## Memo

From: Peter Renshaw, Harbourmaster

## Re: Navigation Safety Report for Proposed Boat Ramp at Māpua

The OCEL report on Boat Ramp currents by G.C.Tear – CPEng.

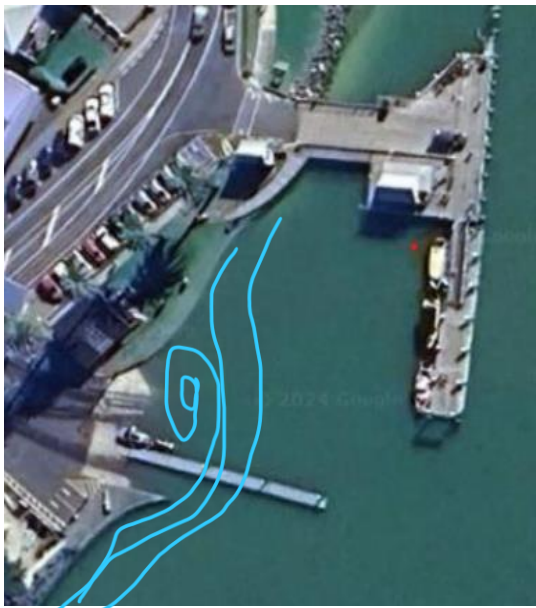
- Significant tidal range in Tasman Bay, this coupled with a large estuary results in significant volumes of water moving through the Mapua Channel
- The initial application contained a report by OCEL report indicates that tidal flow at the ramp site is manageable, with slower currents near the waterline. Meaning a degree of skill would be needed to maneuver a vessel through the faster current but the current would slow before the vessel gets to close to the trailer.
- OCEL report concludes that the proposed ramp could be an all tide ramp for experienced boat operators aware of the strong flow conditions once the boat is off the trailer.
- The Navigation safety assessment uses a few examples of ramps in locations with similar current, however they all have some form of current deflector creating a safe eddy in which to approach the ramp this is not evident in the application.
